**RELEASED FOR CONSTRUCTION**  
As Noted on Plan Review

Development Services Department  
Lee's Summit, Missouri  
03/14/2024

**MANOR AT BAILEY FARMS, FIRST PLAT  
STREET, STORMWATER, AND MASTER DRAINAGE  
PLAN  
SE BAILEY ROAD AND SE RANSON ROAD  
LEE'S SUMMIT, MISSOURI**

BAILEY FARMS  
 PKWY NORTH  
 PLAN & PROFILE

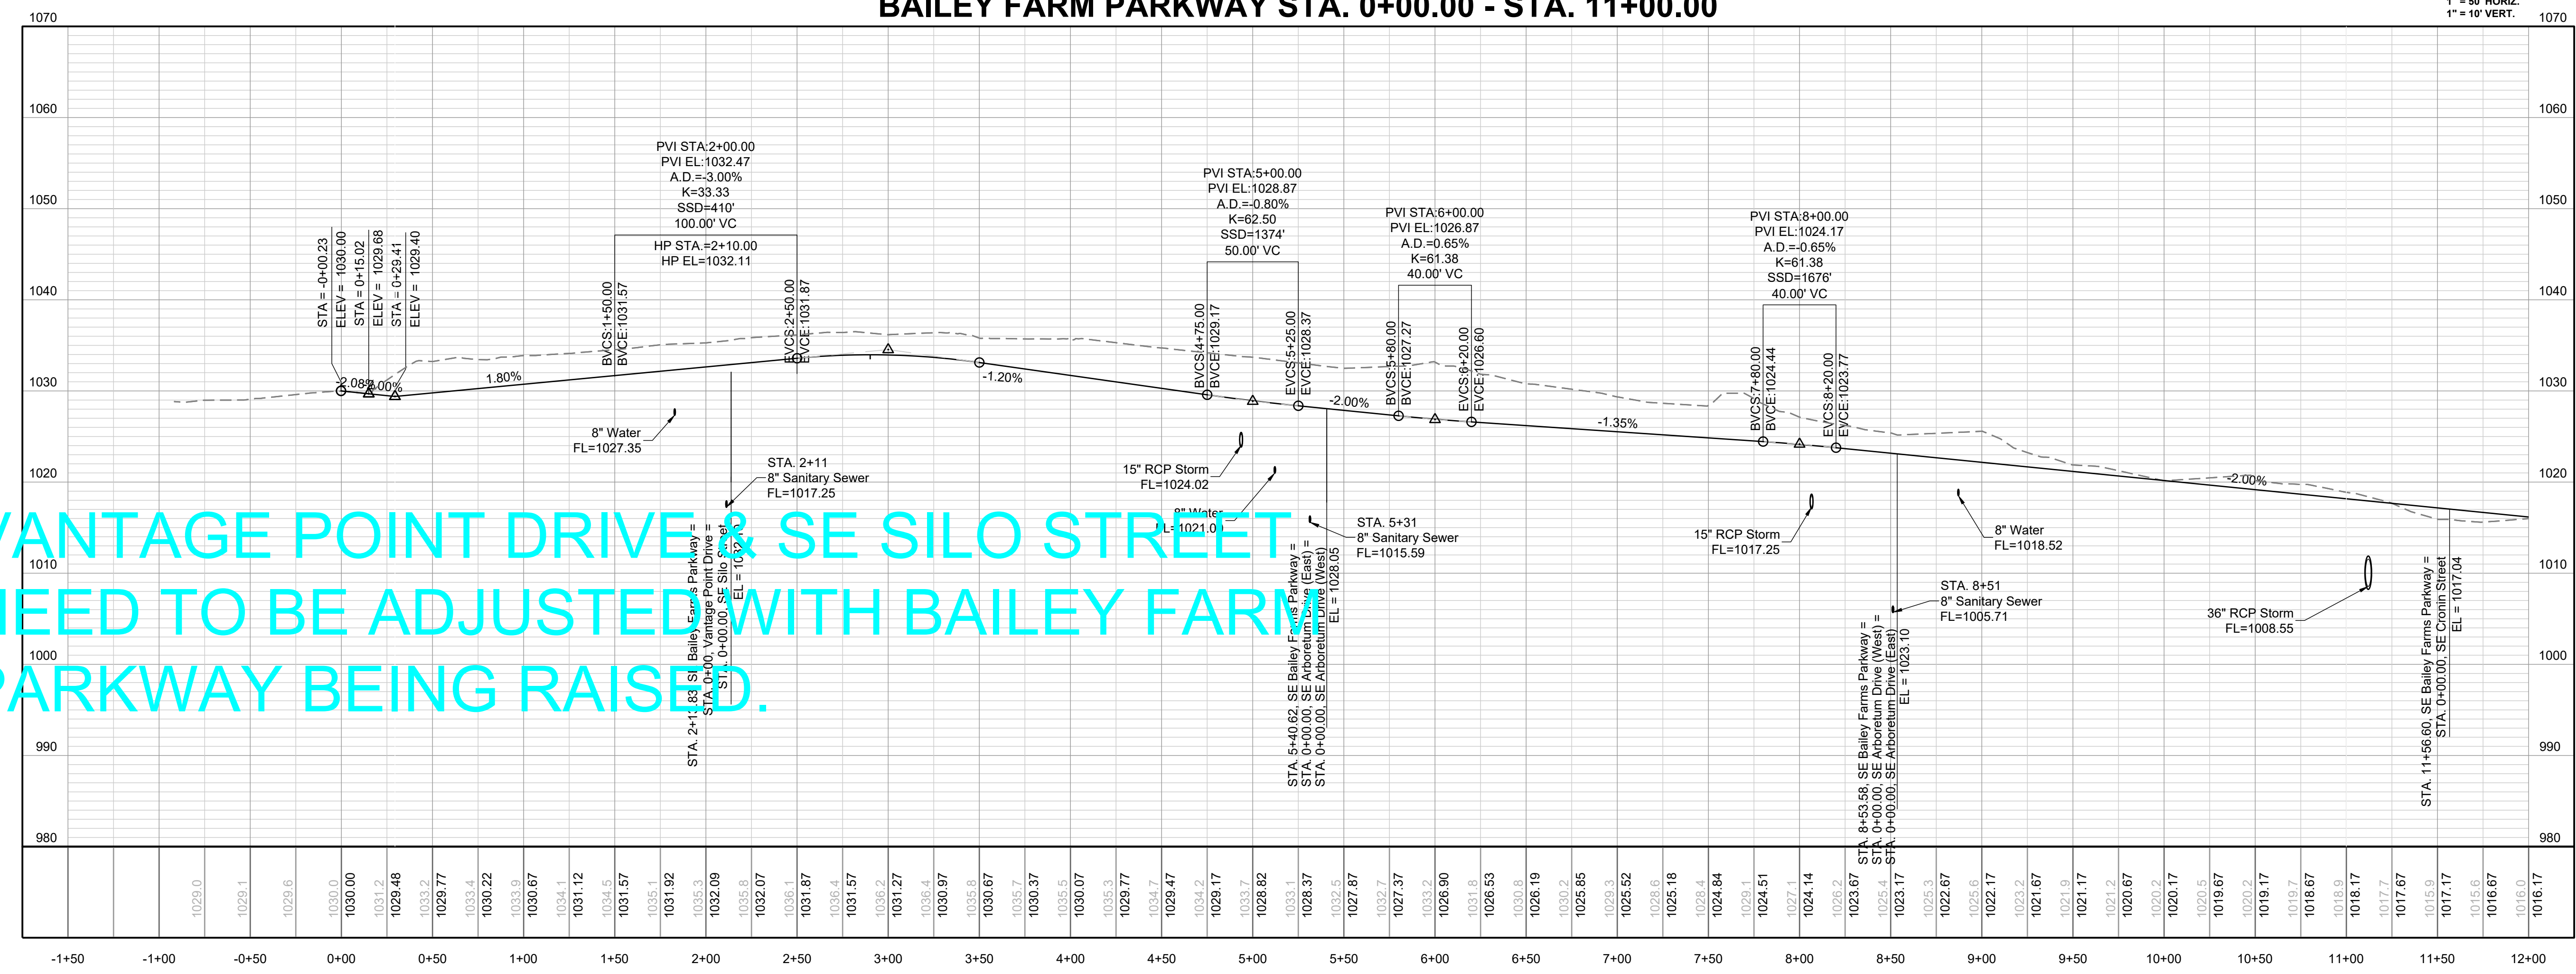
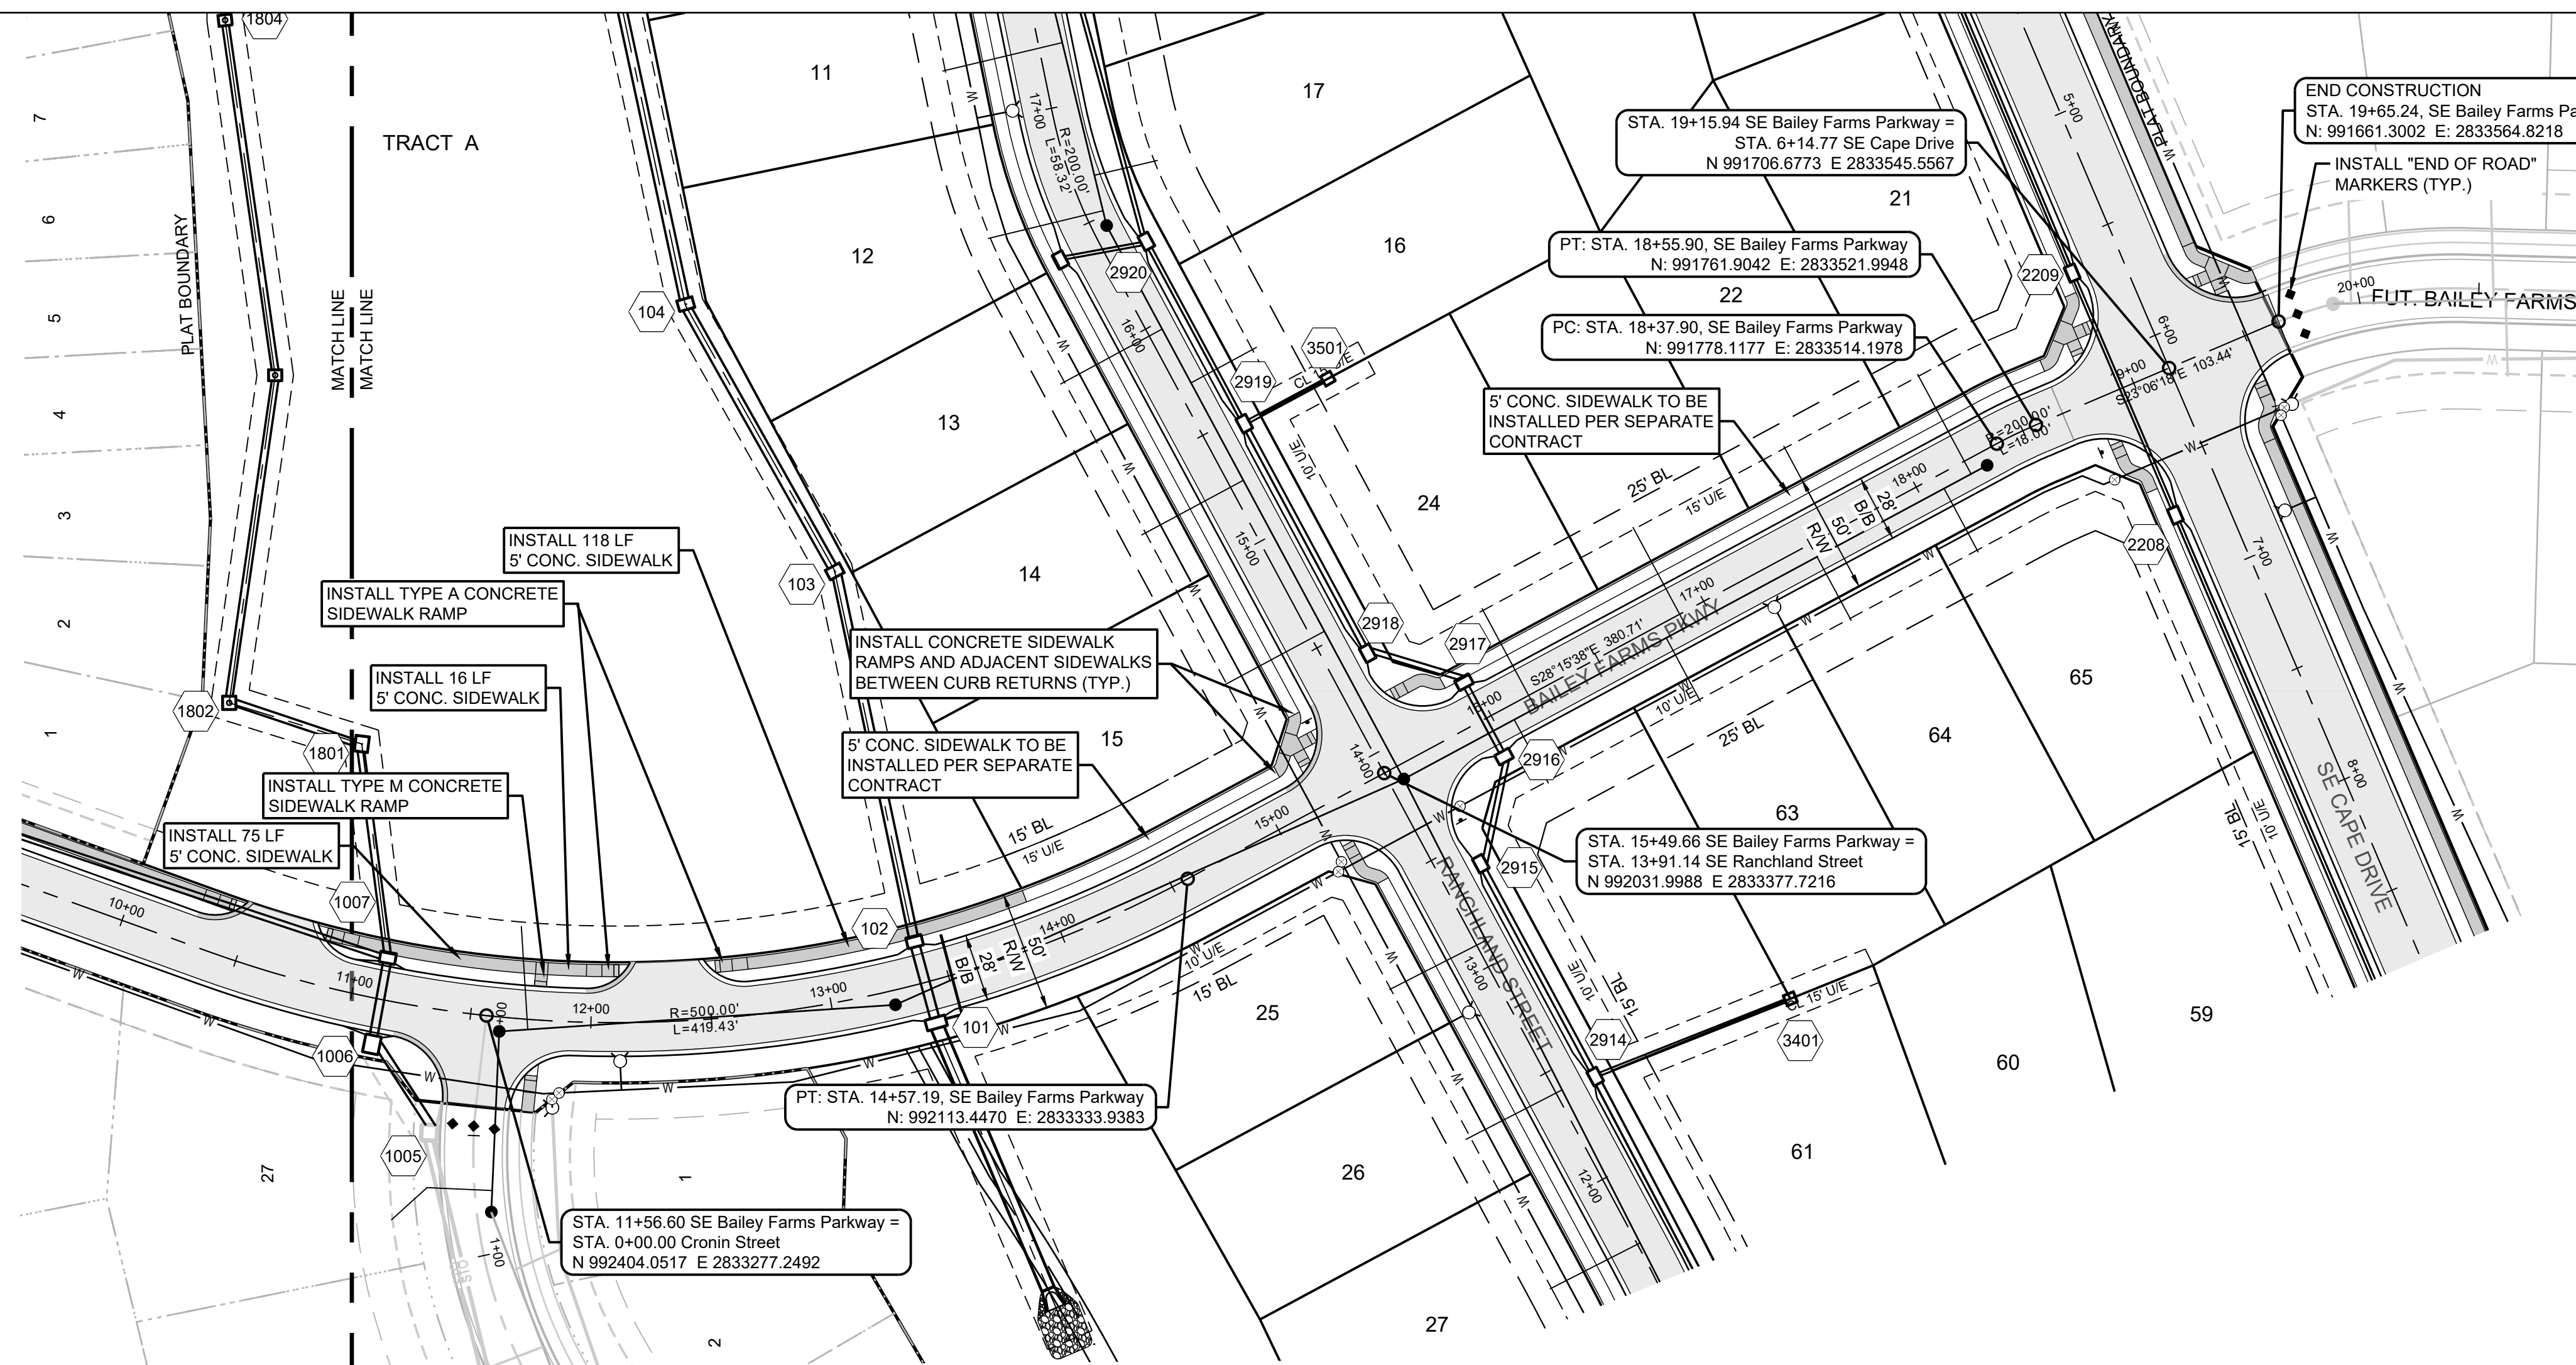
VANTAGE POINT DRIVE & SE SILO STREET  
 NEED TO BE ADJUSTED WITH BAILEY FARM  
 PARKWAY BEING RAISED.

INTERSECTION  
DETAILS 8 OF 8

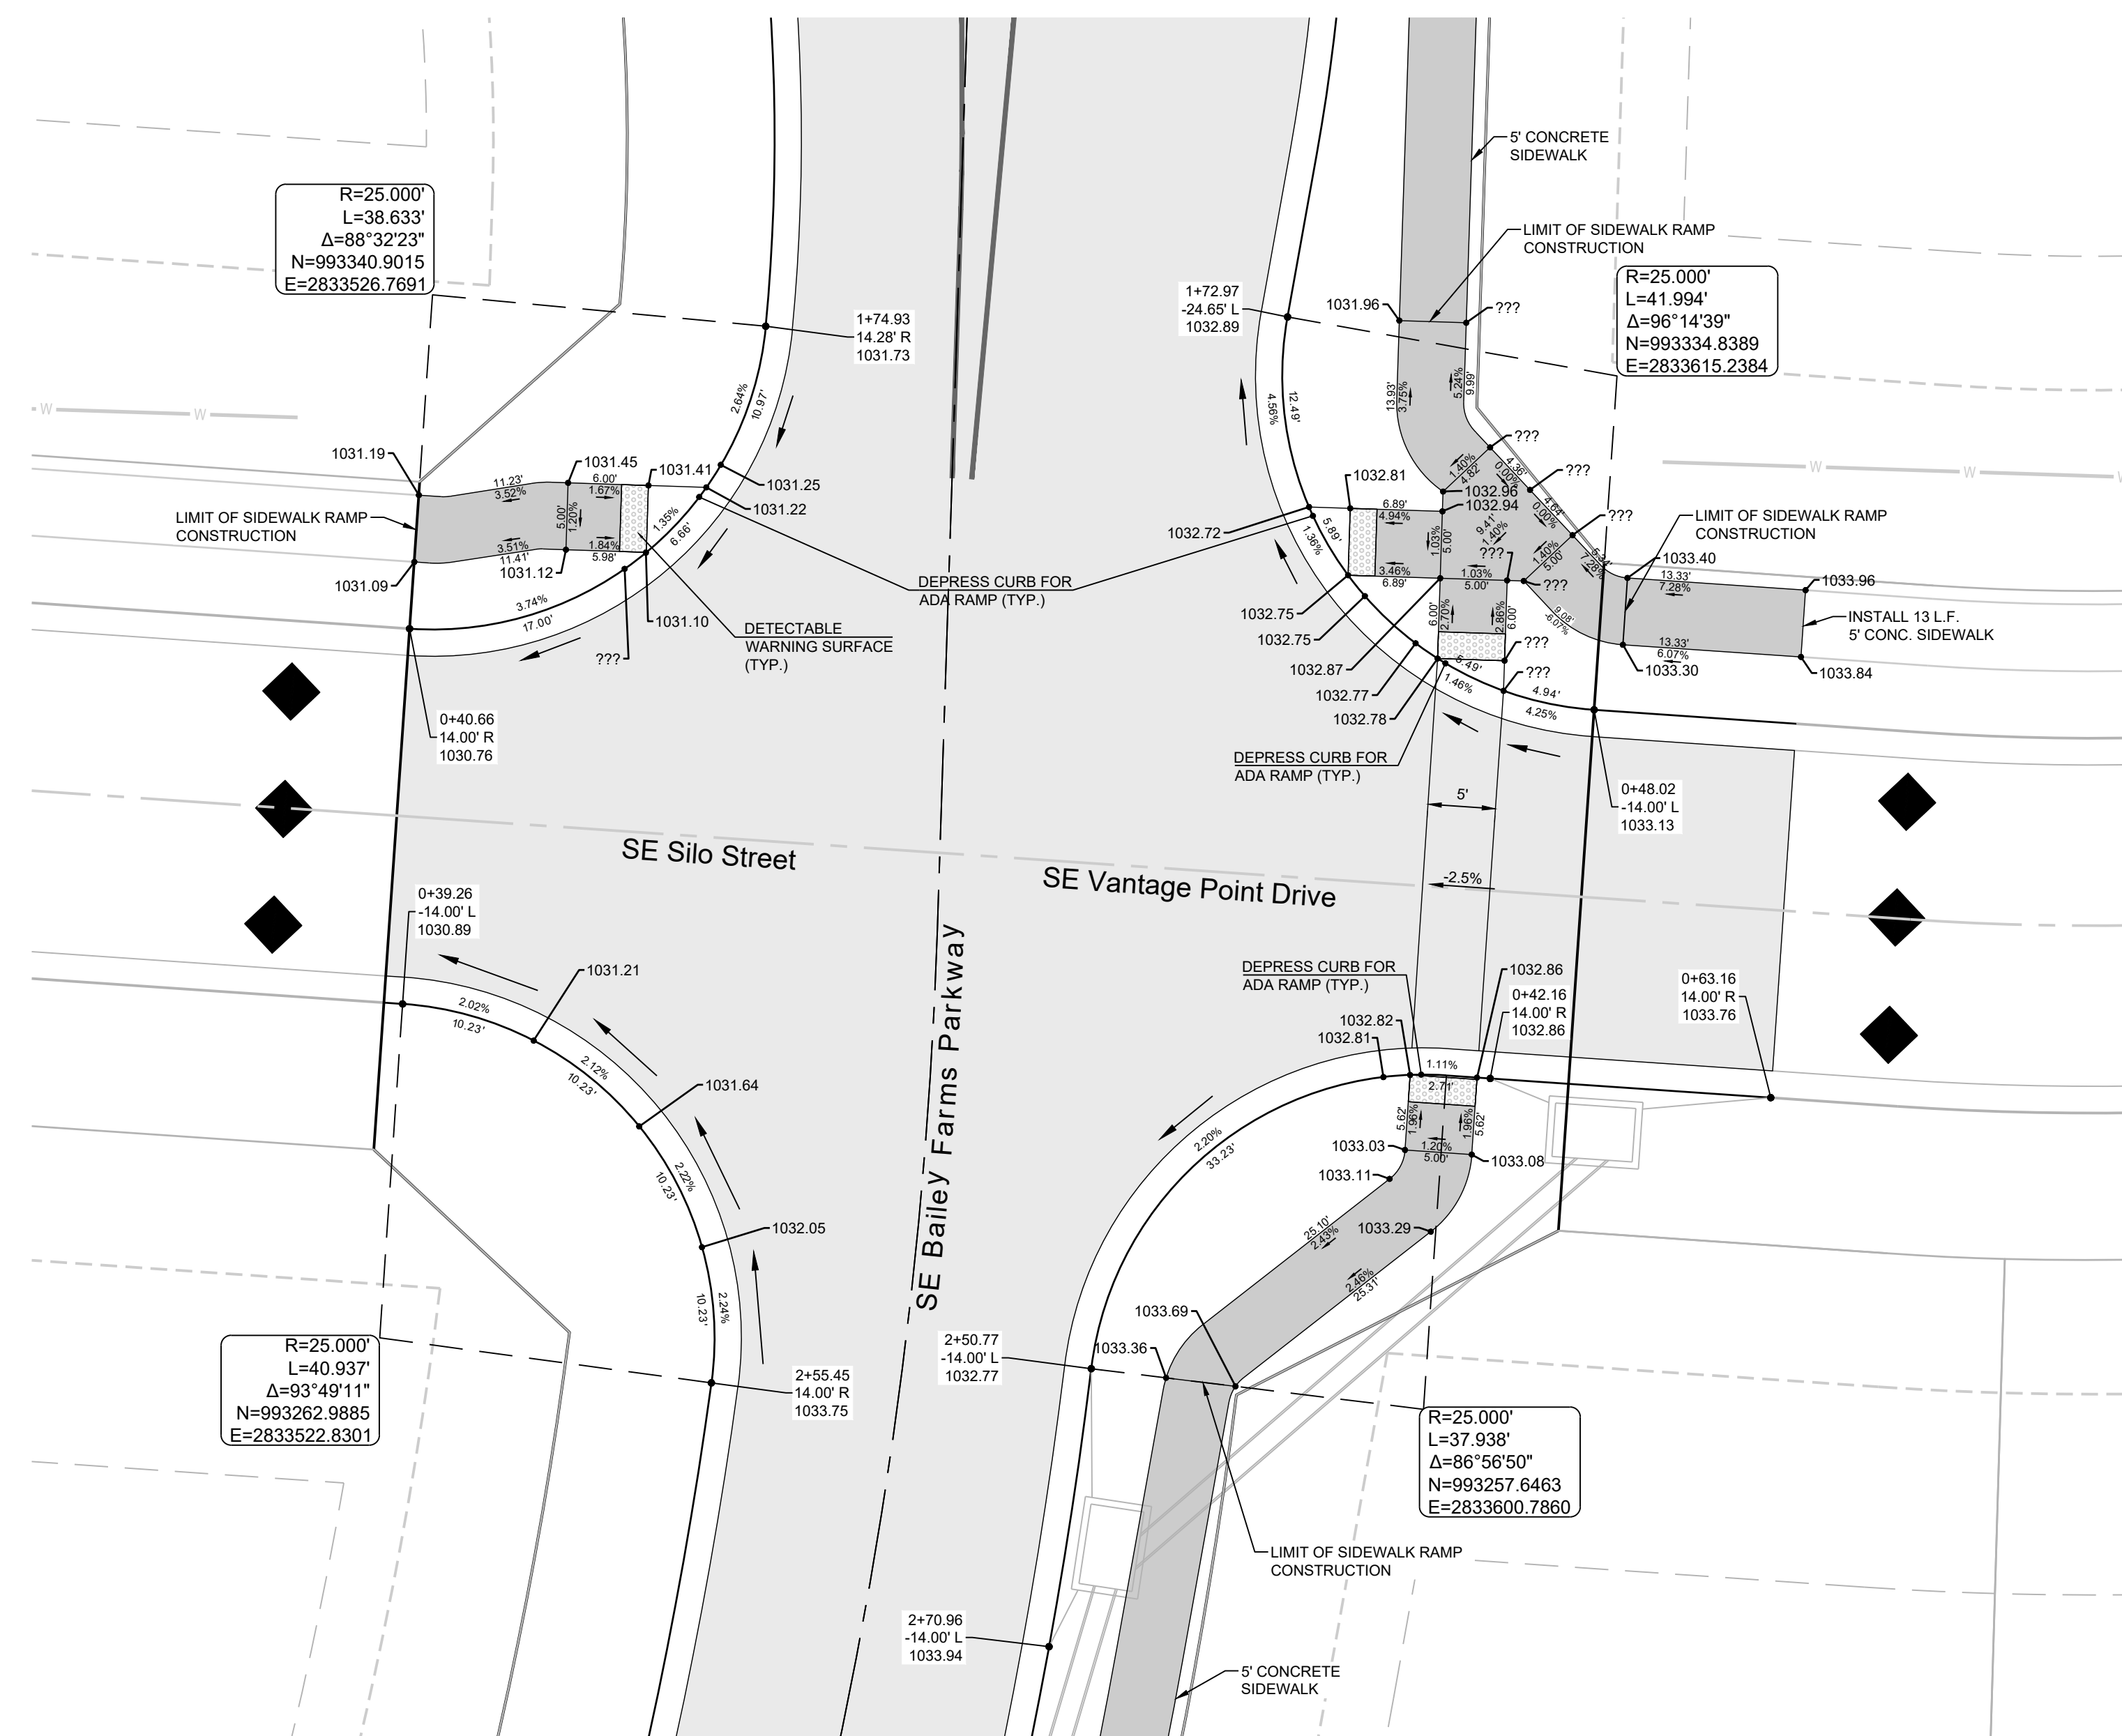
**\*\*NEED TO BE UPDATED PER NEW STREET PROFILE AND SECTION. NO LONGER CROWNED NORTH OF INTERSECTION. WILL NEED DRY CURB.**
